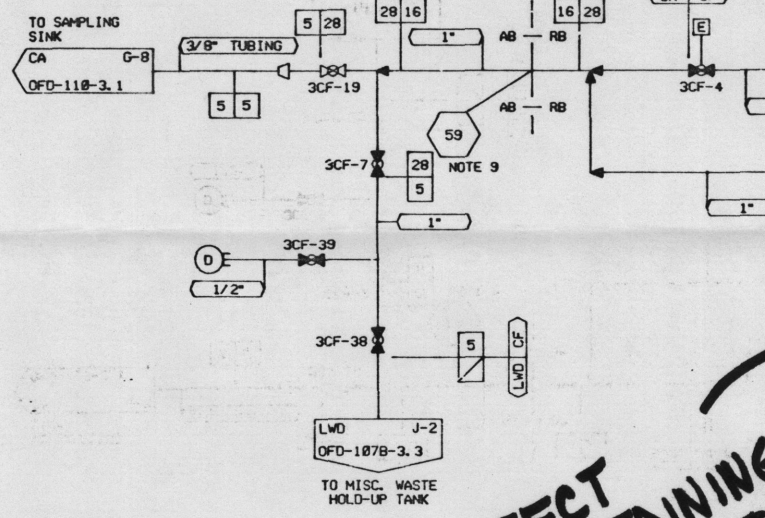
**SUBJECT  
WELD PERTAINING  
TO REQUEST FOR  
RELIEF**
